FIRE SAFETY INSPECTION REPORT

**PANORAMA APPARELS LTD.
VOGRA (BASAN SARA), P.O-NATIONAL
UNIVERSITY, SADAR**

ACCORD
on Fire and Building Safety in Bangladesh

September 10, 2014

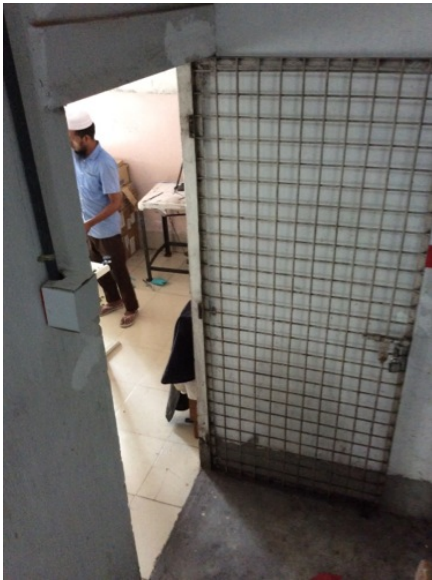
F-2	Fire Rated Construction	Area used for combustible storage on the 2nd floor is not separated by fire-rated construction.	Provide dedicated storage rooms separated by minimum 1-hr fire-rated construction. Where separate storage rooms are not feasible, provide defined storage areas and limit the storage arrangement as follows: - Maximum height of 2.4m and maximum area of 23m² - If sprinkler protected: maximum height of 3.66m and maximum area of 93m² Separate areas of unenclosed combustible storage by a minimum clear distance of 3m.	Within 3 months
-----	-------------------------	---	--	-----------------

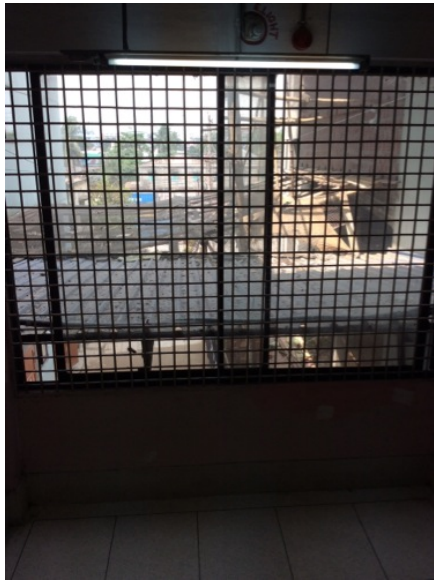
F-3	Fire Rated Construction	Rooms used for combustible storage on the ground, 1st and 2nd floors are not separated by fire-rated construction.	Provide dedicated storage rooms separated by minimum 1-hr fire-rated construction.	Within 3 months
-----	-------------------------	--	--	-----------------

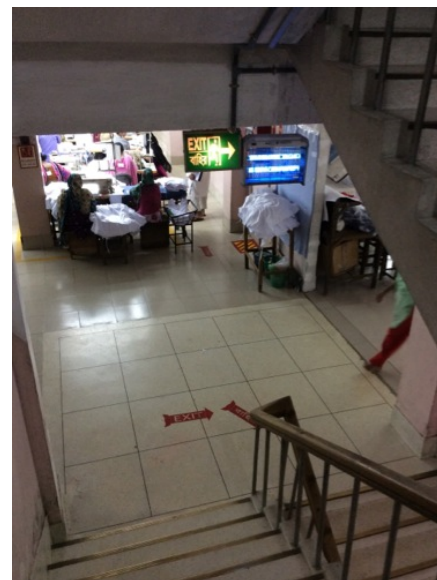
F-4	Fire Rated Construction	The exit stairs are not separated from work areas on each floor by fire-rated construction.	Provide minimum 1.5-hr fire rated doors and seal all unprotected openings to separate the exit stairs from work areas on all floor levels. Ensure that the fire doors are self-closing and positive latching and that they are provided with fire exit (panic) hardware where serving production floors. If fire doors are required to be held open for functional reasons, provide automatic-closing devices tied to the fire alarm system.	Within 3 months
-----	-------------------------	---	--	-----------------
